PORTLAND PUBLIC ART COMMITTEE

Wednesday, December 16, 2020
4:00 p.m. – 6:00 p.m. Online via Zoom

DEERING CORNER ROUNDABOUT
Stone Bench Sketch - Review with
Artist
11/19/20
Sebago Technics, Inc.

SKETCH 4A

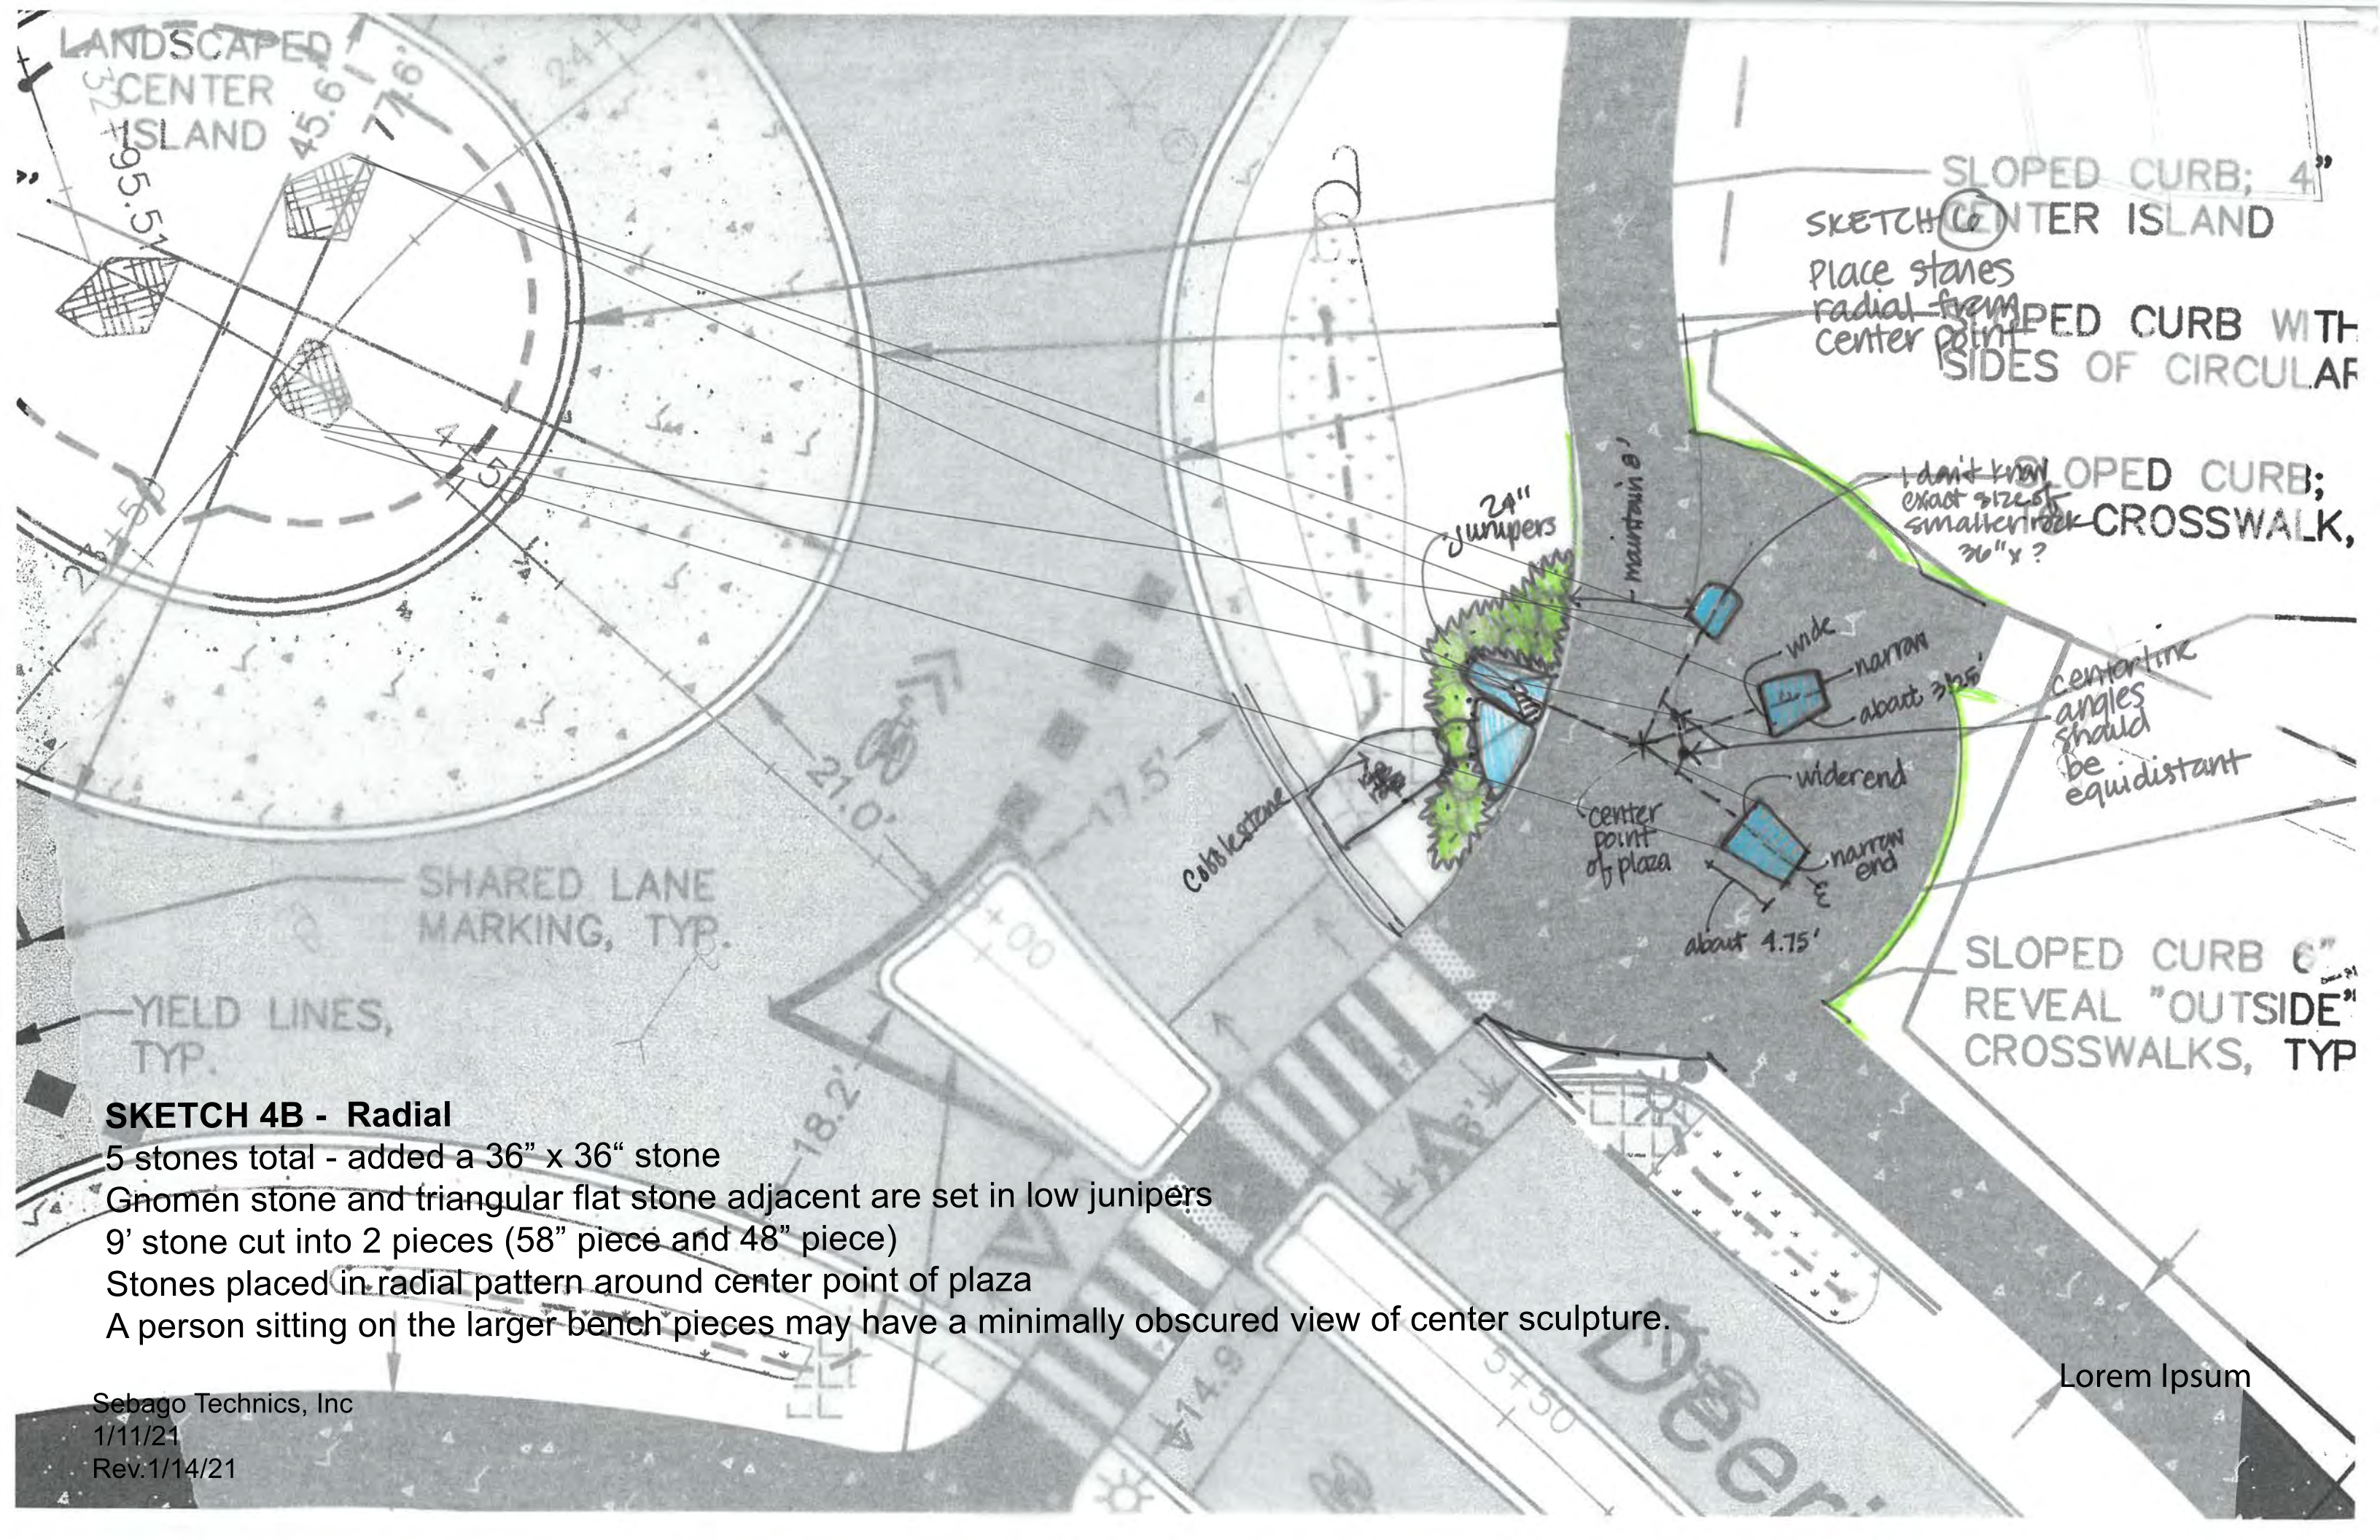
5 stones total - added a 36" x 36" stone
Gnomen stone and triangular flat stone adjacent are set in low junipers
9' stone cut into 2 pieces (58" piece and 48" piece)
A person sitting in the middle bench stone would have a partially obscured view of center sculpture. The other two stones would have open views.

SKETCH 4B - Radial

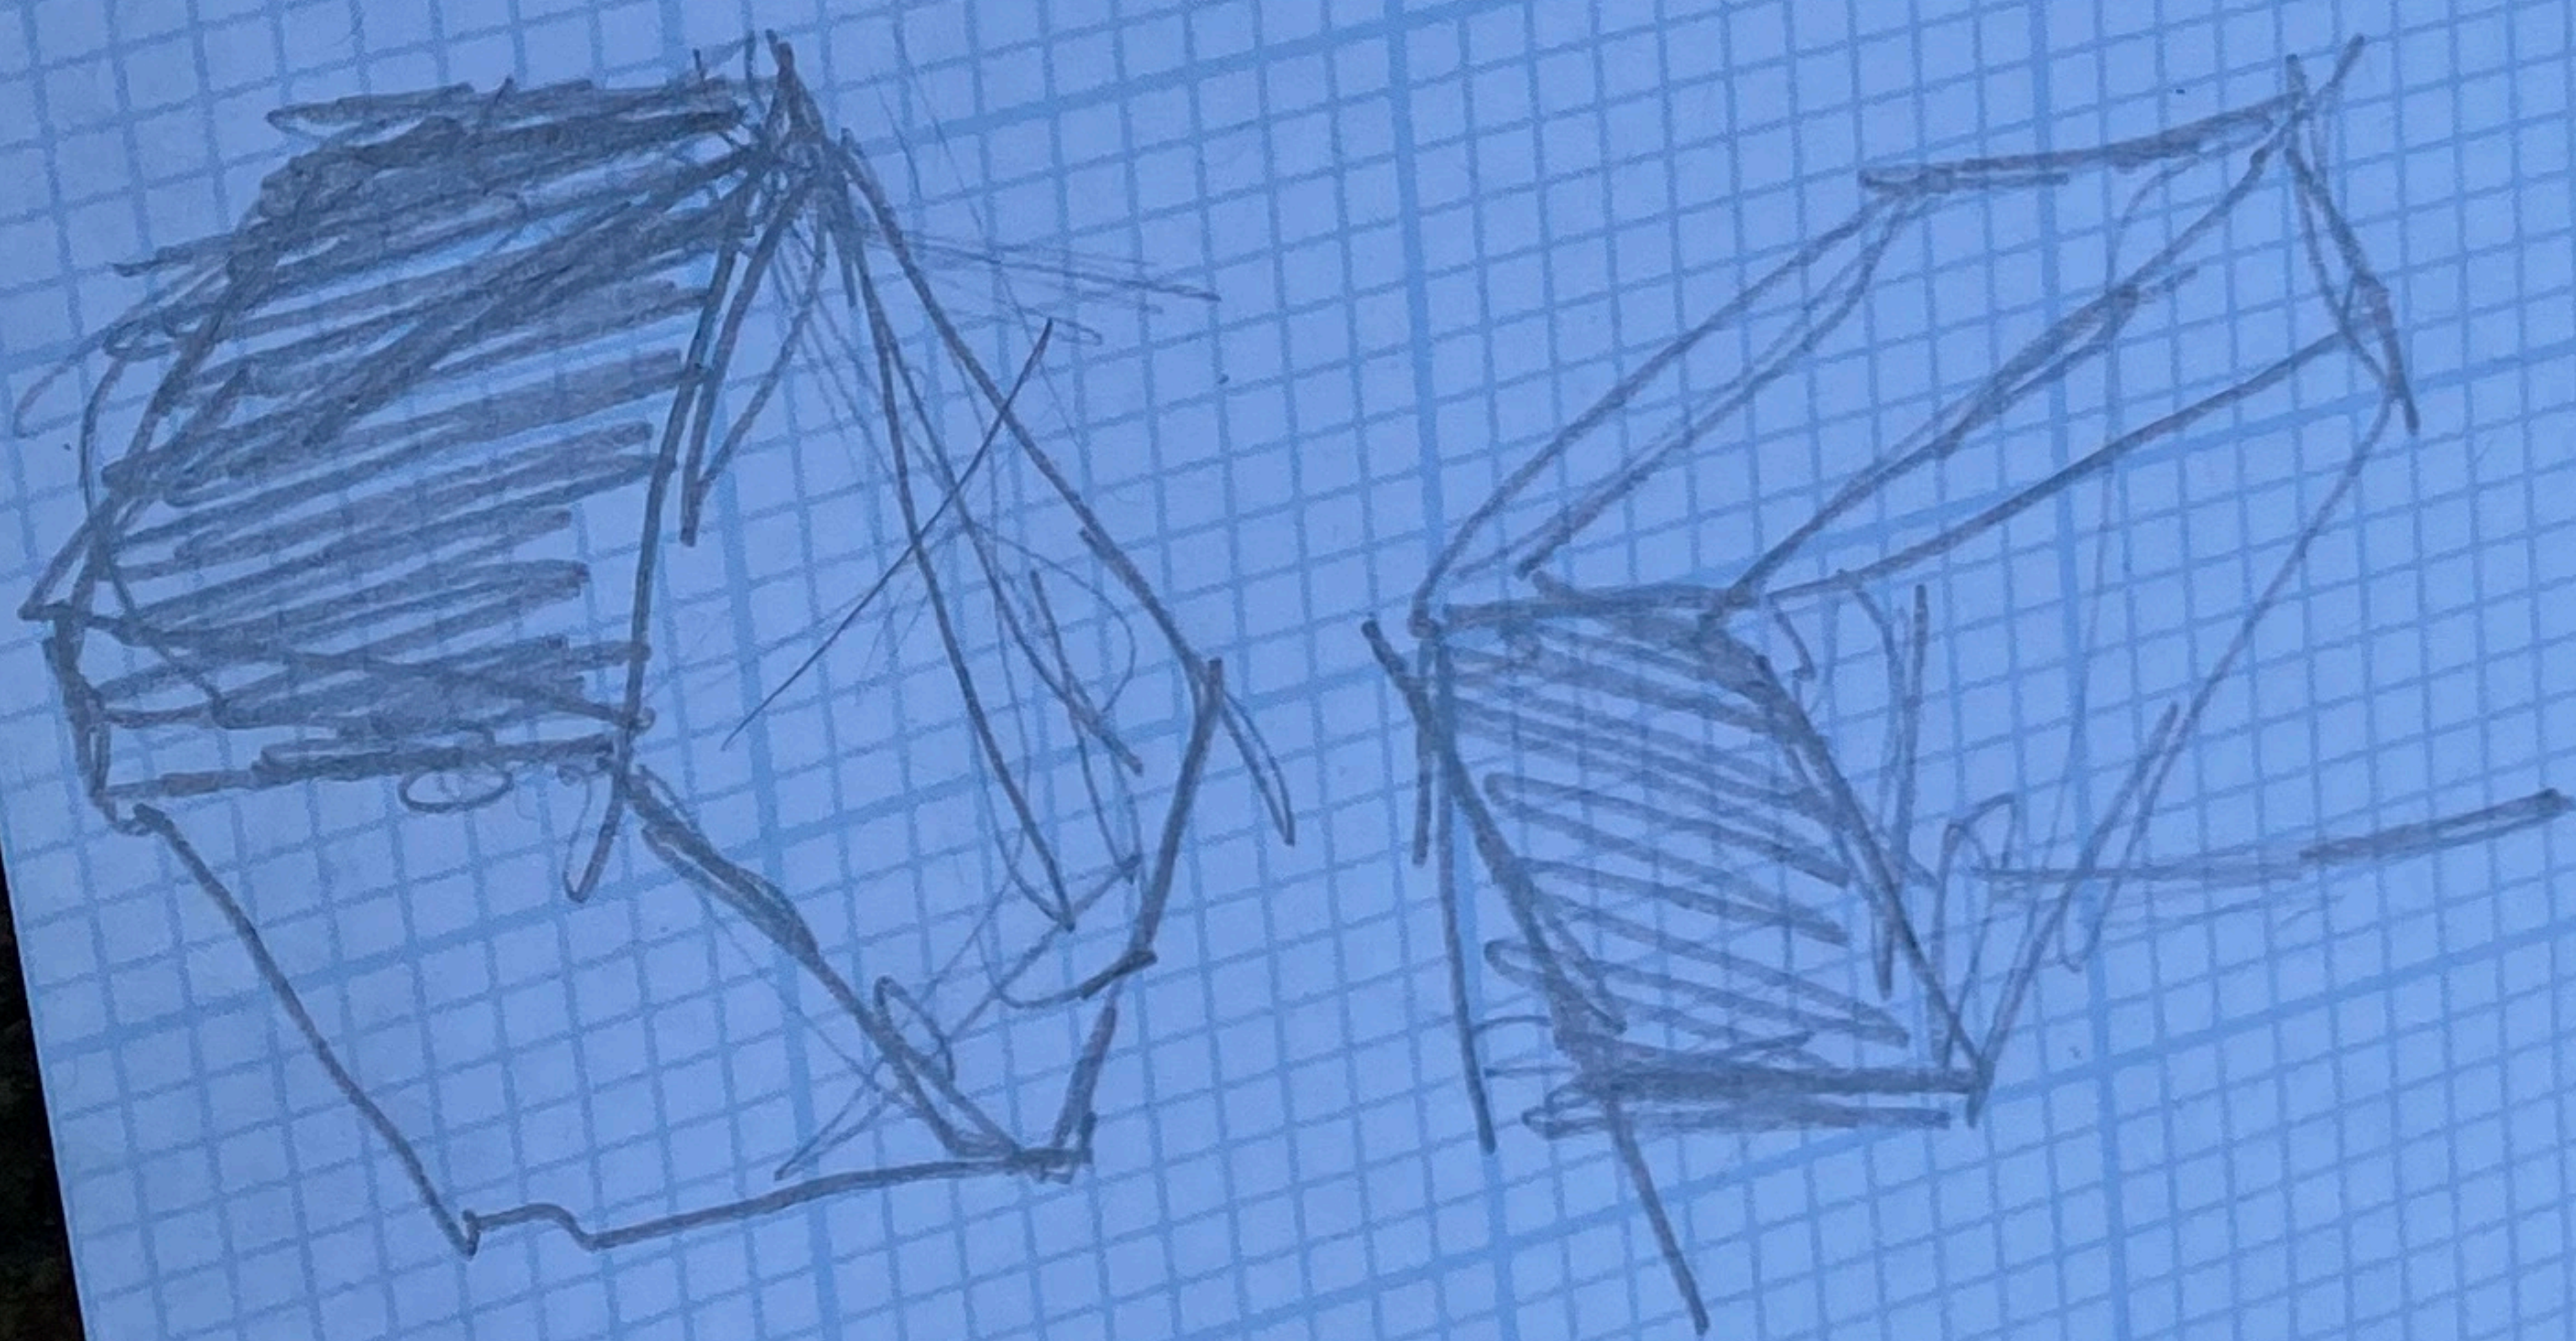
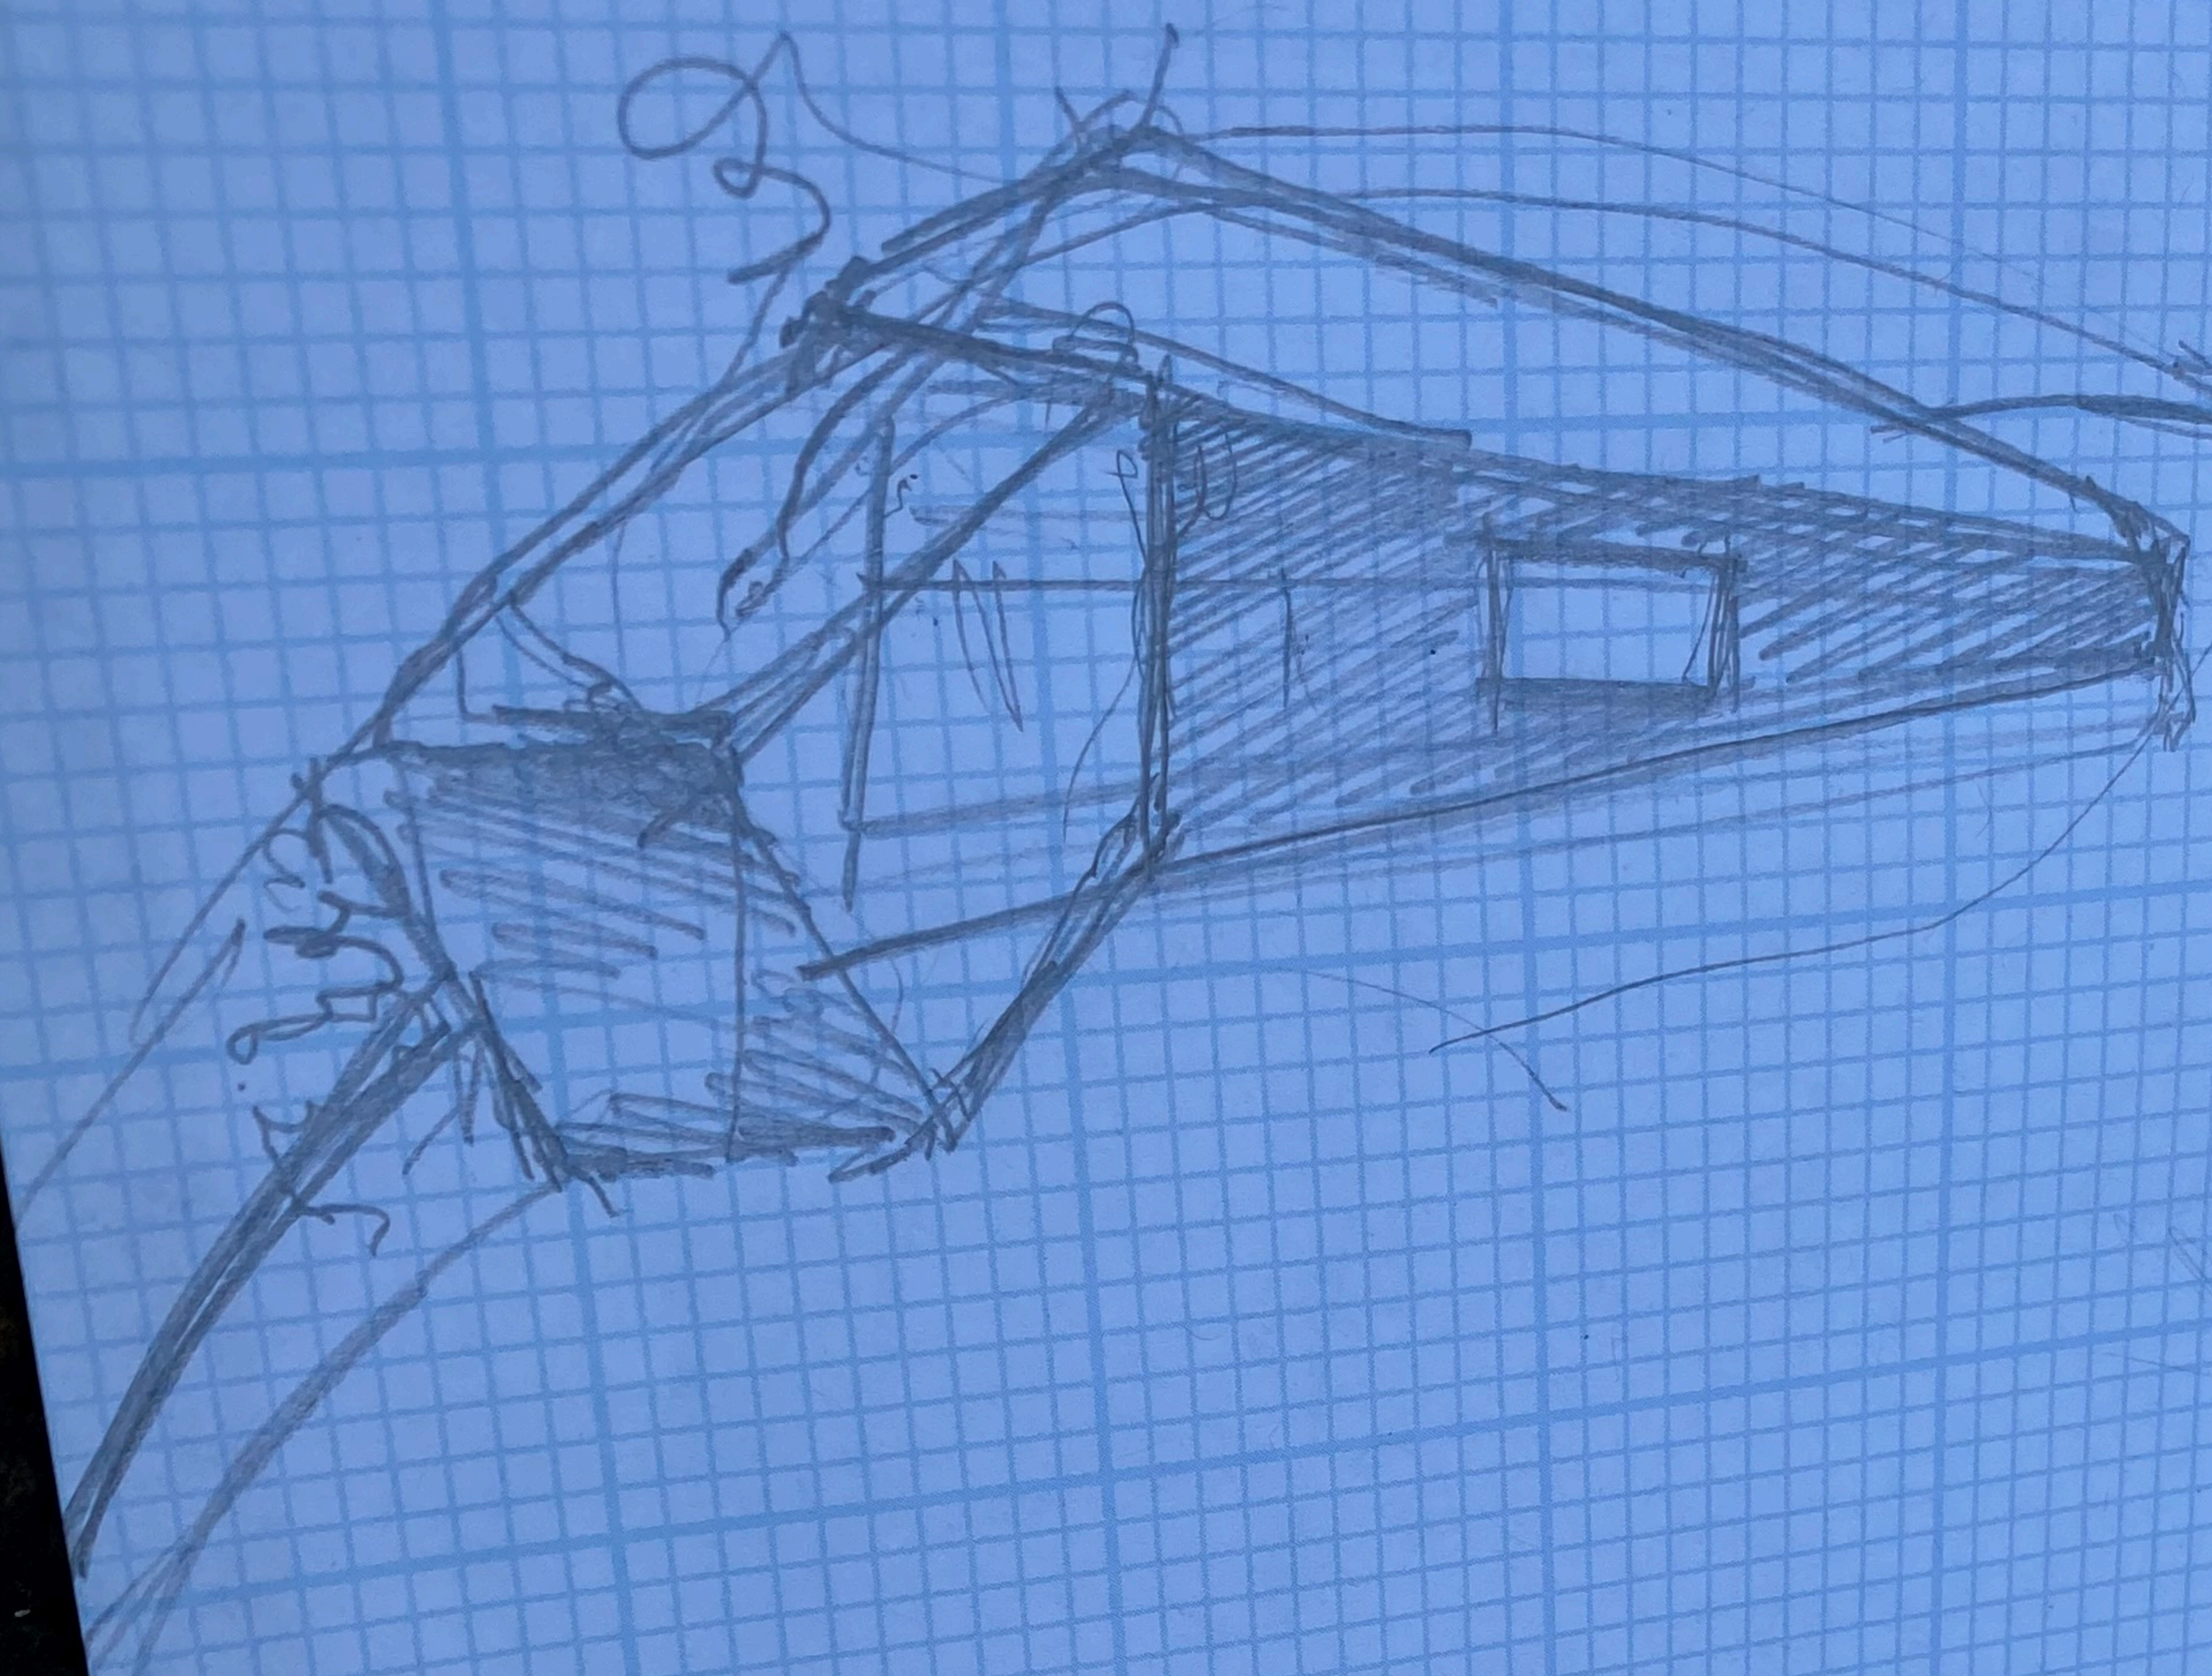
- 5 stones total - added a 36" x 36" stone
- Gnomen stone and triangular flat stone adjacent are set in low junipers
- 9' stone cut into 2 pieces (58" piece and 48" piece)
- Stones placed in radial pattern around center point of plaza
- A person sitting on the larger bench pieces may have a minimally obscured view of center sculpture.
